Rev.	Date	By	Ckd	Description
I	17/08/2023	WN	DN	S4.56 Issue 2

30 Fairlight St, Fairlight
30 Fairlight St,
Fairlight, NSW 2094

- SCHEDULE OF CHANGES**
1. Planter and deepsoil reduced to accommodate relocation of mailbox for DDA compliance.
 2. Amendment to location of carpark lobby doors
 3. OSD tank extended to accommodate minimum volume as per Stormwater Engineer's report.
 4. Additional door added for compliance as alternate fire egress with NCC D2D6.
 5. Landscaping and planter replaced with terrace hardscape to accommodate OSD tank volume below.
 6. Wall of front terrace rationalised for buildability
 7. Window opening reconfigured.
 8. Internal layout reconfigured and rationalised
 9. Plant services added onto roof including AC condensers, hot water units and mechanical vent exhausts to be concealed with metal screen enclosure
 10. PV panels added.
 11. Skylights deleted.
 12. Solid access hatch cover amended to glazed hatch.
 13. Courtyard landscape amendment.

DA201
G

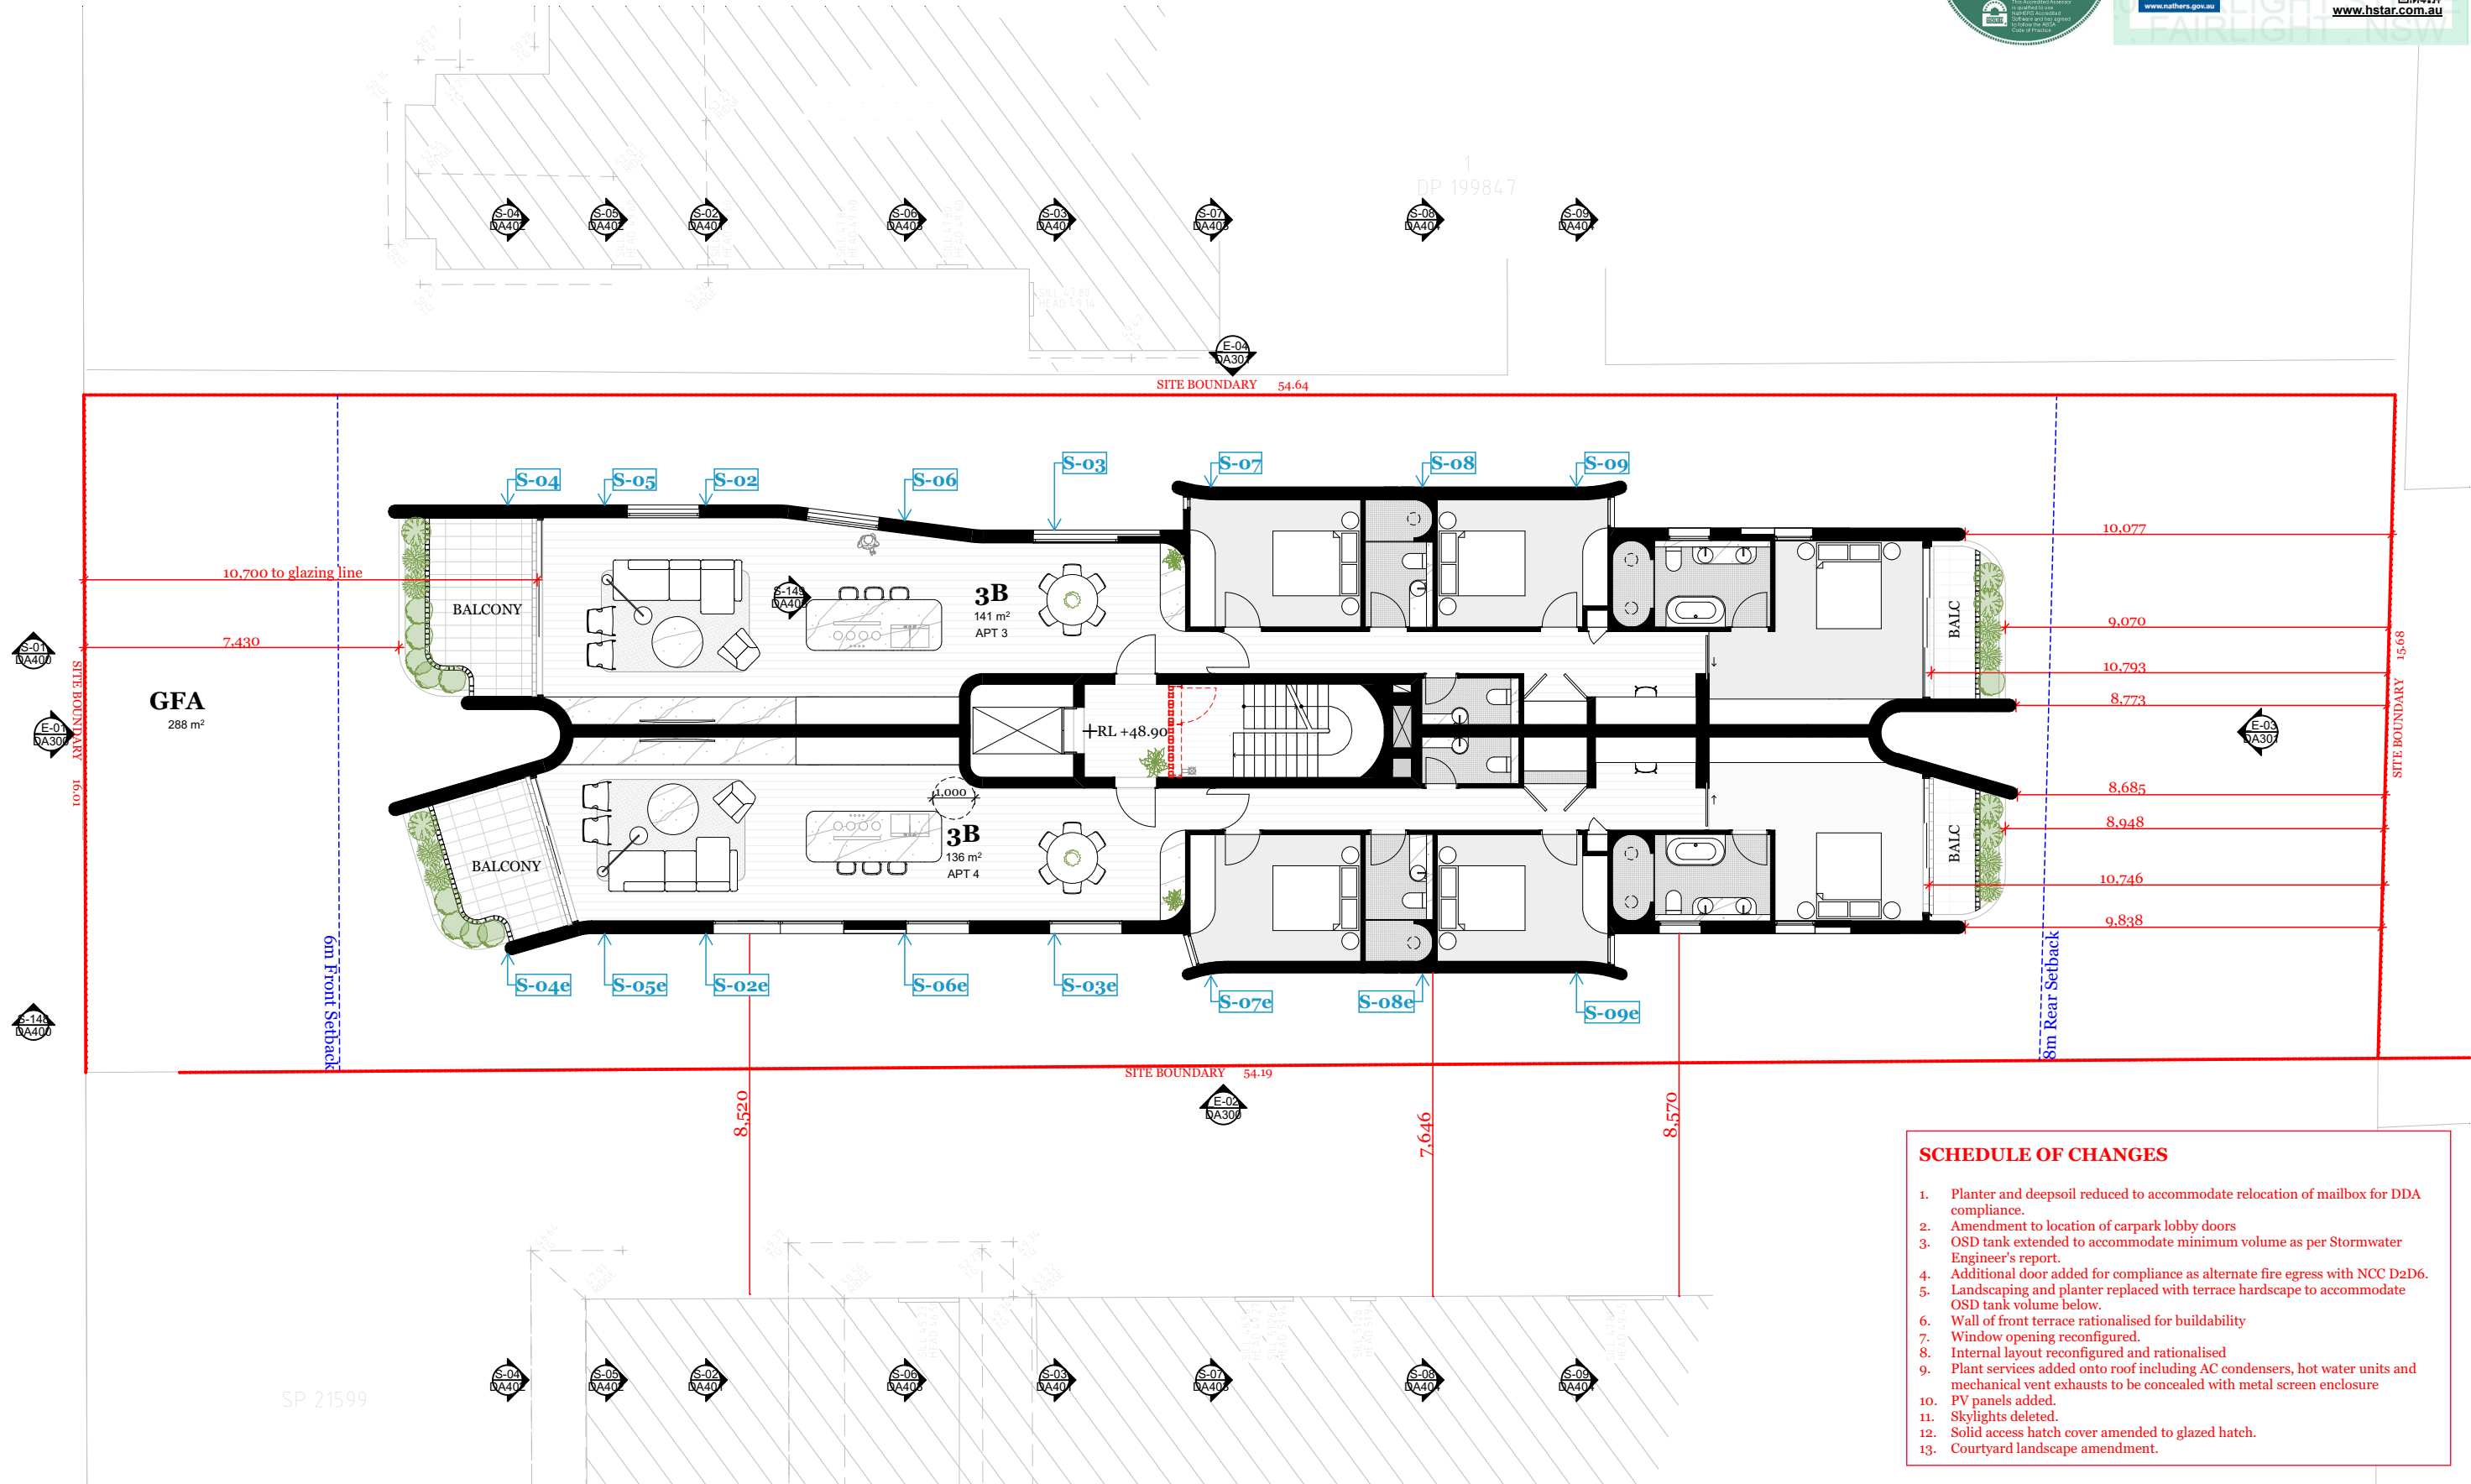
- SCHEDULE OF CHANGES**
1. Planter and deepsoil reduced to accommodate relocation of mailbox for DDA compliance.
 2. Amendment to location of carpark lobby doors
 3. OSD tank extended to accommodate minimum volume as per Stormwater Engineer's report.
 4. Additional door added for compliance as alternate fire egress with NCC D2D6.
 5. Landscaping and planter replaced with terrace hardscape to accommodate OSD tank volume below.
 6. Wall of front terrace rationalised for buildability
 7. Window opening reconfigured.
 8. Internal layout reconfigured and rationalised
 9. Plant services added onto roof including AC condensers, hot water units and mechanical vent exhausts to be concealed with metal screen enclosure
 10. PV panels added.
 11. Skylights deleted.
 12. Solid access hatch cover amended to glazed hatch.
 13. Courtyard landscape amendment.

DA202
G

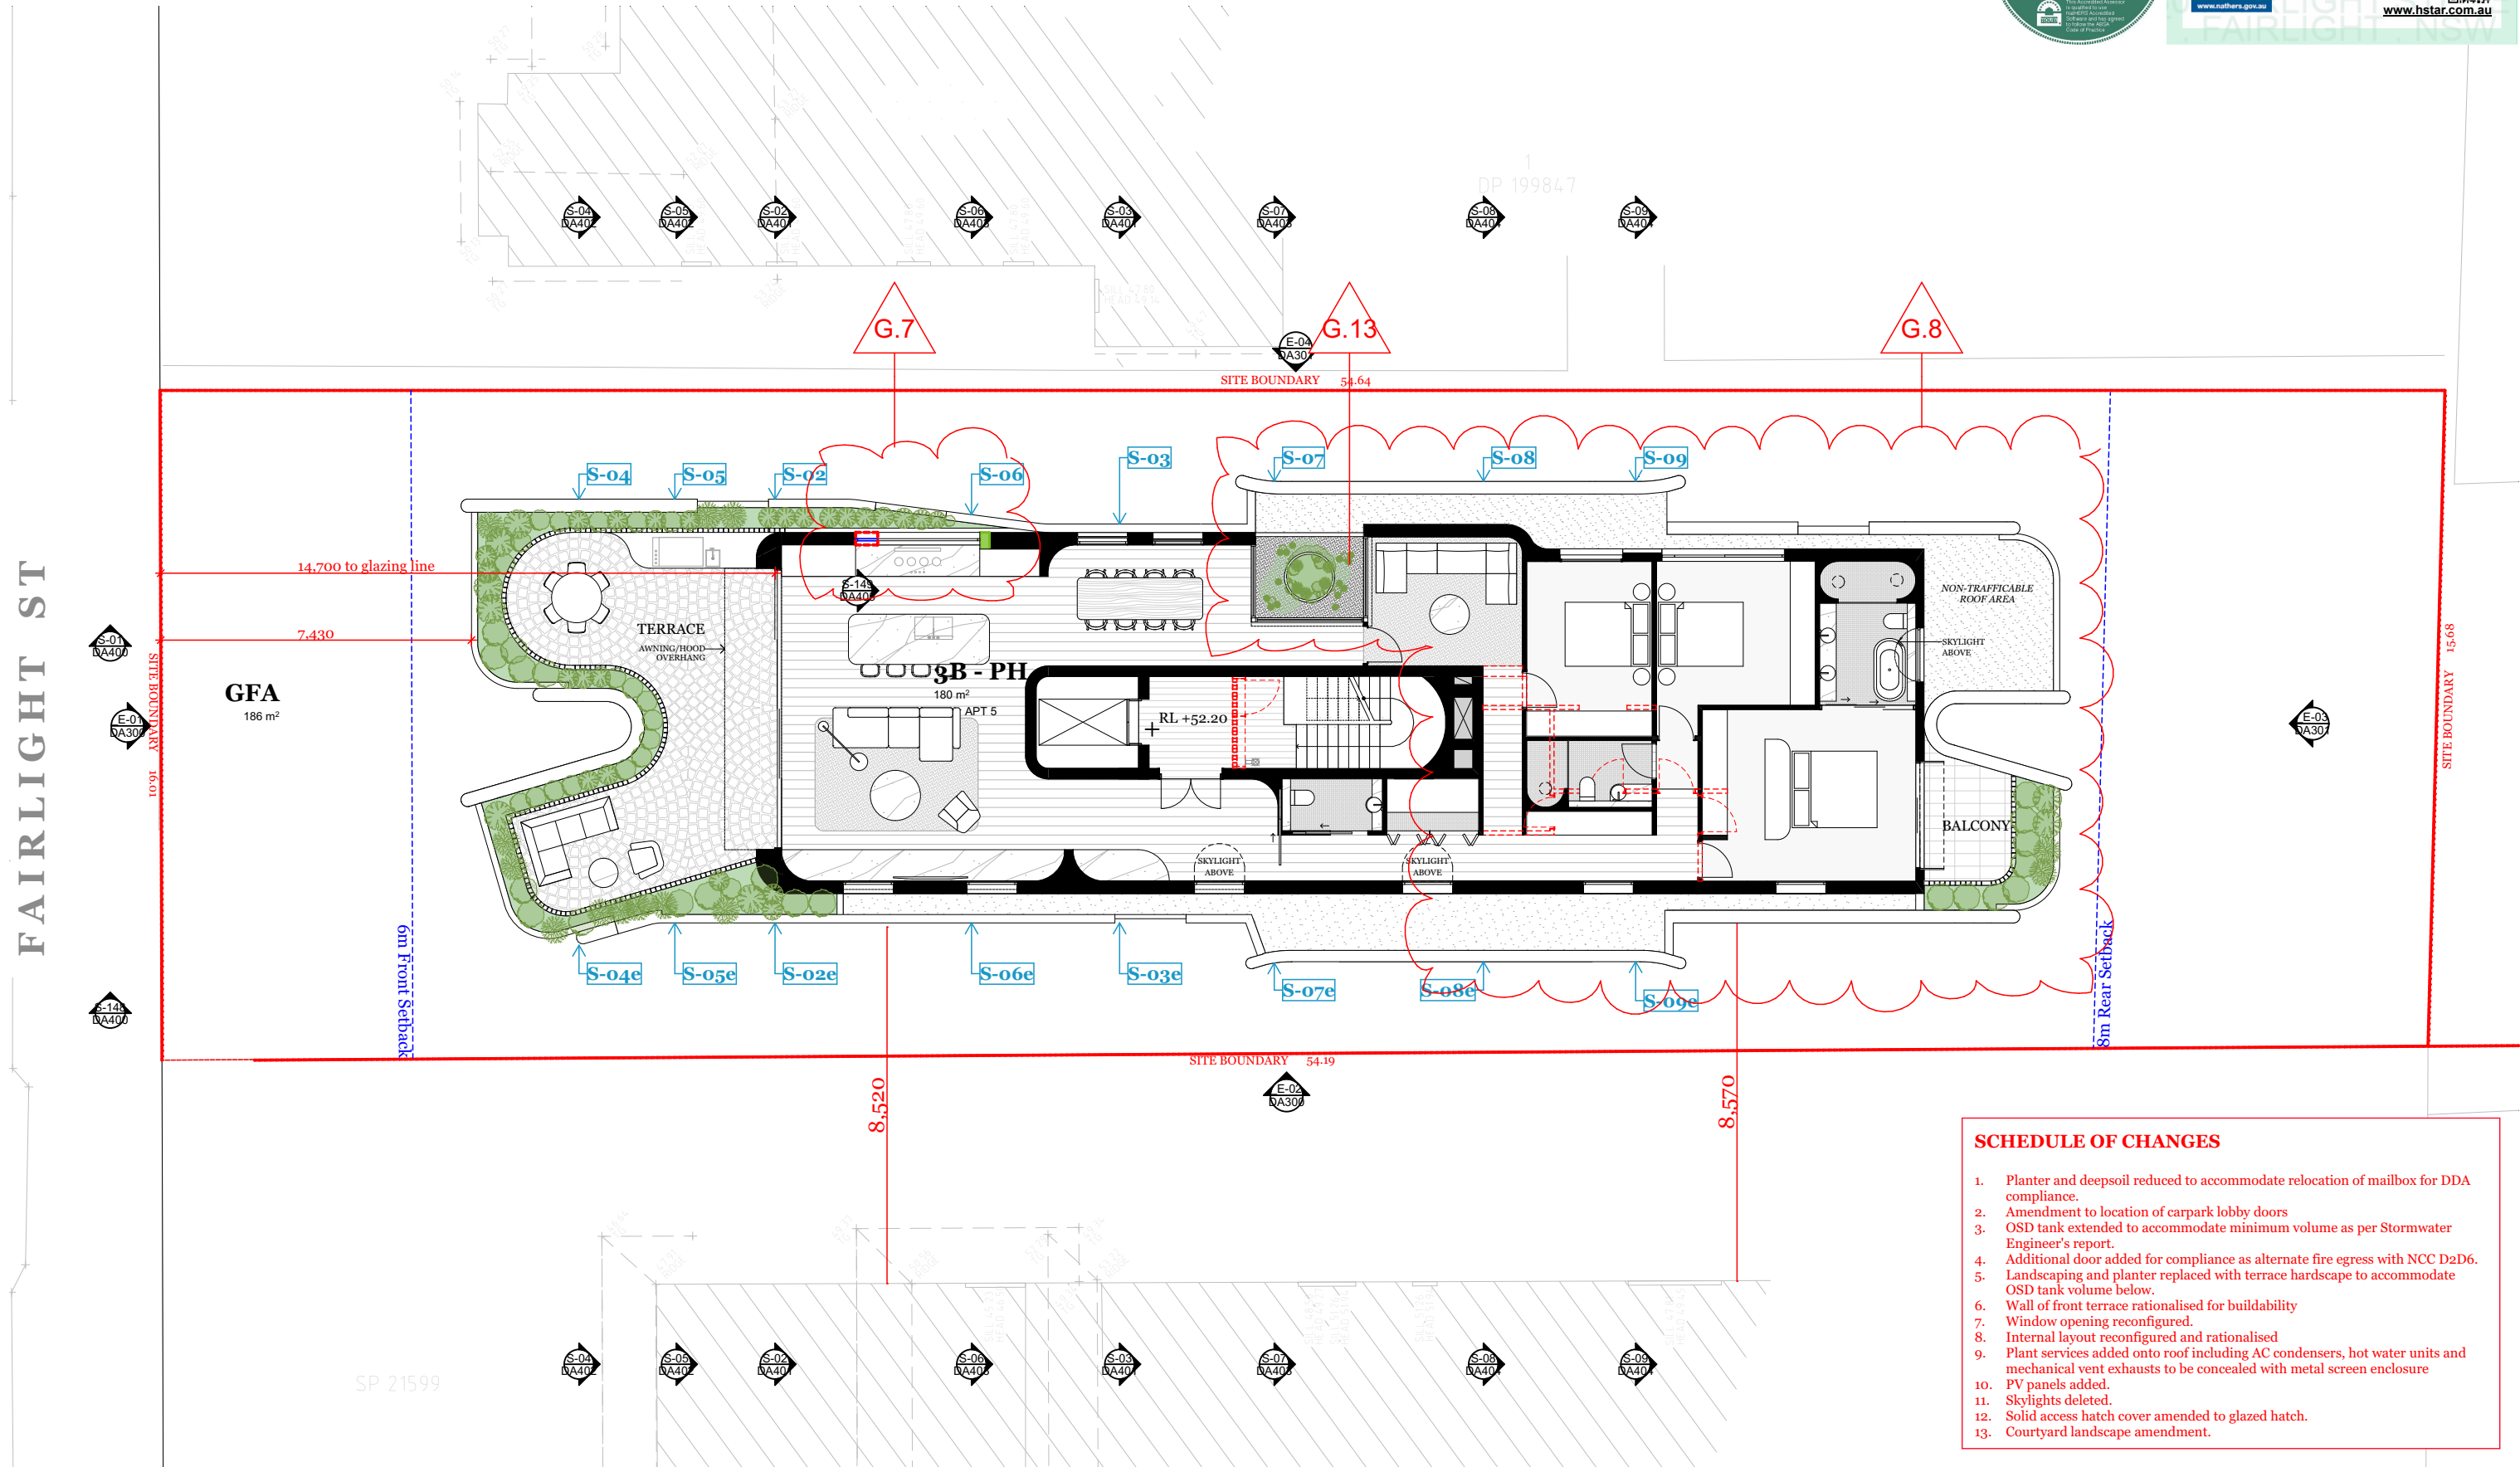
- SCHEDULE OF CHANGES**
1. Planter and deepsoil reduced to accommodate relocation of mailbox for DDA compliance.
 2. Amendment to location of carpark lobby doors
 3. OSD tank extended to accommodate minimum volume as per Stormwater Engineer's report.
 4. Additional door added for compliance as alternate fire egress with NCC D2D6.
 5. Landscaping and planter replaced with terrace hardscape to accommodate OSD tank volume below.
 6. Wall of front terrace rationalised for buildability
 7. Window opening reconfigured.
 8. Internal layout reconfigured and rationalised
 9. Plant services added onto roof including AC condensers, hot water units and mechanical vent exhausts to be concealed with metal screen enclosure
 10. PV panels added.
 11. Skylights deleted.
 12. Solid access hatch cover amended to glazed hatch.
 13. Courtyard landscape amendment.
